PIC18F2480/2580/4480/4580 Silicon Errata and Data Sheet Clarification

The PIC18F2480/2580/4480/4580 family devices that you have received conform functionally to the current Device Data Sheet (DS39637D), except for the anomalies described in this document.

29.1 28-Lead QFN Package Marking Information

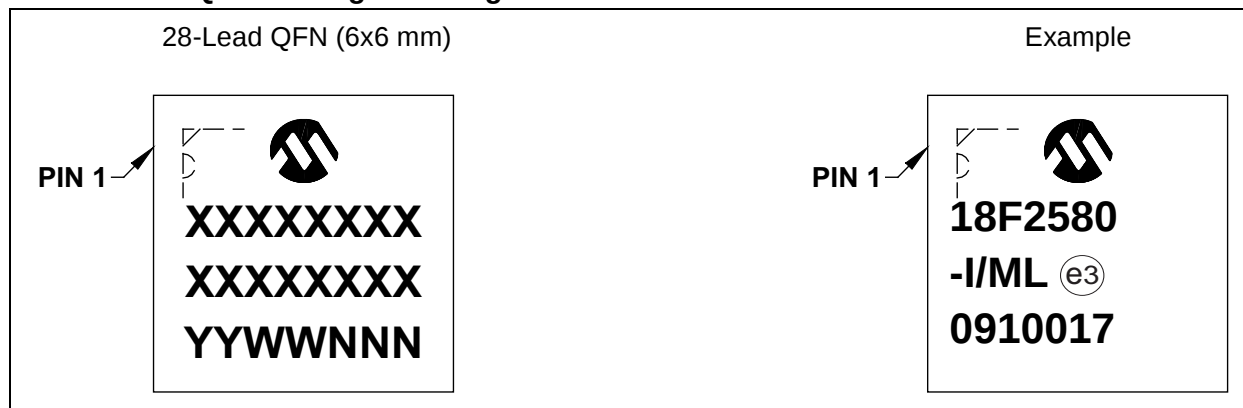
The “Pin 1” dot on the 28-Lead QFN package, in the Package Marking Information section, is incorrectly placed. The correct placement is indicated in [Section 29.1 “28-Lead QFN Package Marking Information”](#) below:
